# The perils of automated fitting of datasets: the case of a wind turbine cost model

April 2019

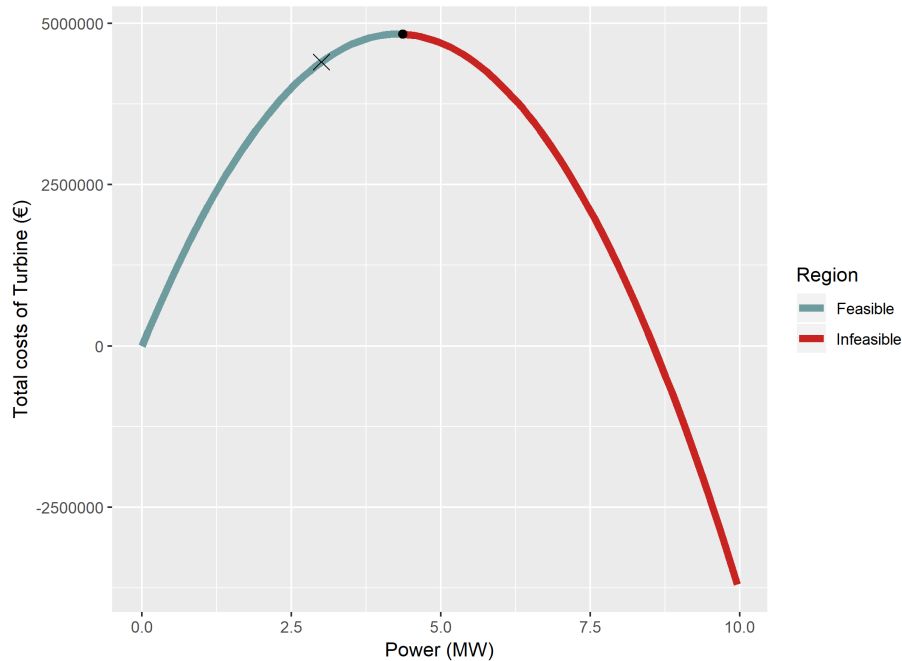
In essence, a consistent model should mirror a realistic scaling behavior of all parameters. For example, in total cost a large turbine needs to be more expensive than a small turbine, although specific costs may decrease with size. Figure 1 shows that basic scaling relations of the rated power  $p$  are violated in equation (3) for certain parameter regimes. It depicts the scaling of investment cost with respect to rated power  $p$  and fixed  $r$ ,  $age$ , and  $hh$  for one of the four turbines discussed in [1], assuming a hub height of 75 meters.

Note, that equation (3) has a quadratic term in  $p$ , therefore the function has one maximum. For  $p$  above that maximum, total turbine costs decrease in absolute terms while increasing rated capacity  $p$ . This is counter-intuitive and cannot be explained by economies of scale, which should at best lead to declining marginal increases in total cost.

We refer to  $p$  values below the maximum cost as plausible region (shown in turquoise) and above the extremum as implausible (shown in red). Here, plausible means that a point on the curve may replicate real cost behaviour, even though we make no judgement on the correctness of the result in this

regime. In contrast, points in the implausible region seem incorrect a priori due to an implausible scaling. In the implausible region, increasing turbine capacity, everything else being equal, will decrease cost predicted by the cost model. For some values, turbine costs even become negative. However, the turbine models in [1] are all in the plausible range.

Rinne et al. need to explicitly limit the parameter space of their model to ensure validity of their results or replace the model by a different specification. Figure 1's scaling in the regime of implausibility shows that after a certain point generators are predicted to be cheaper in absolute numbers if installed with a higher output. This behaviour is concerning since the field of power system analysis relies heavily on numerically solving optimization problems. If (2) is inputted into a numerical optimization solver without further precautions that ensure that the solver is restricted to the plausible region, optimal solutions may be implausible.

Figure 2: Assessment of all turbines in US Wind Turbine Database [2]. Red turbines are in the plausible regime, while blue turbines are in the implausible region. Calculations are performed through the R-Script from [5]

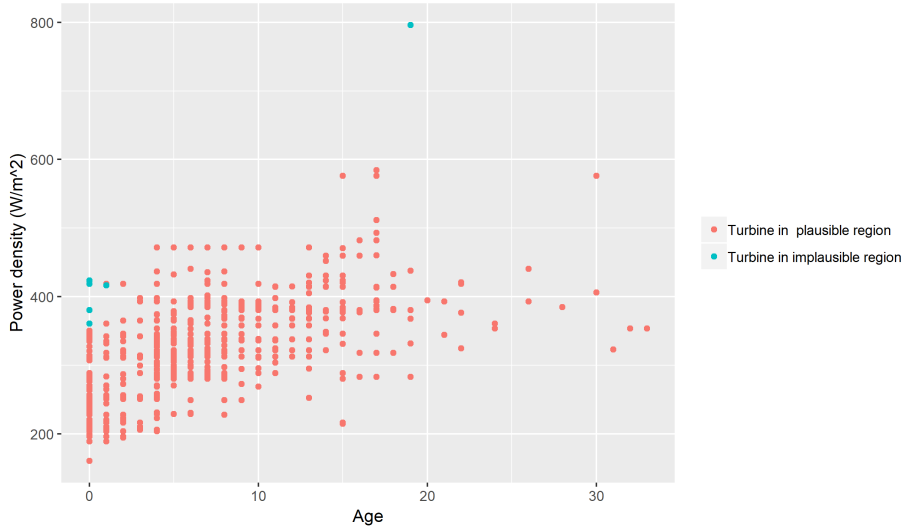
One could presume that any reasonable choice of turbine parameters remains in the plausible region. This, however, is not the case. Building on the US wind turbine database [2] (which includes hub height, rotor length, rated capacity and date of installation), we have determined whether all distinct 650 turbine types are within the plausible region<sup>1</sup>. Figure 2 indicates that several real turbines are actually outside the plausible region, i.e. their costs most likely are underestimated by the Rinne et. al. model (3). The real turbines that fall outside the model's regime of validity tend to be new and have relatively high specific power.

Observe that specific power is a ratio of two parameters. Thus, high specific power is attained in two different ways: either by installing larger generators or smaller blades. While smaller rotors certainly lead to lower cost, a higher rated capacity requires a larger generator, increasing costs. This illustrates that varying two different parameters may both cause a high specific power, even though both processes have opposite effects on cost. Figure 2 shows that this is empirically relevant.
